Reference is made to your "Fourth Review of Intention to Commence Large Mining Operations", Basin Perlite Company, Pearl Queen Mine M/001/027, Beaver County, Utah. This Review was dated June 12, 2001.

Reply to Fourth Review of Notice of Intention to Revise Mining Operations, Basin Perlite Company, Pearl Queen Mine M/001/027, Beaver County Utah, Dated June 12, 2001.

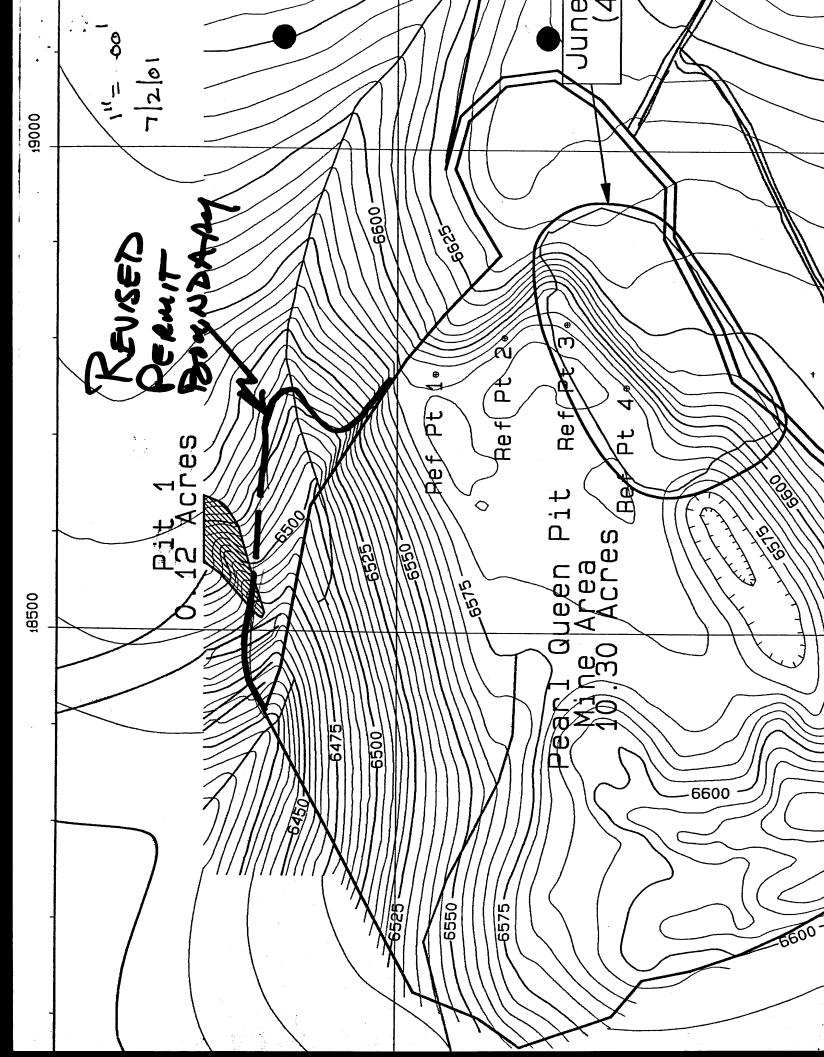
106.5 Existing soil types, location, amount.

The rubble, rock, and soil berm that has been dozed off Pit No. 3 (Schoo Pit), and that remains on the proposed mine area is small. The berm is no more than 400 feet long, a maximum of 10 feet wide, perhaps 5 feet high and is discontinuous. We estimate that no more than 500 tons of such material is present. We did not submit a soil sample from Pit No.3 because there is no soil in place. In April we requested that the 96-1 sample be used. The bedrock geology and soil types are the same at both sites and the soil sample site is only about 1500 feet away from Pit No.3. May we use this analysis to represent the Pit No. 3 area? (Attached).
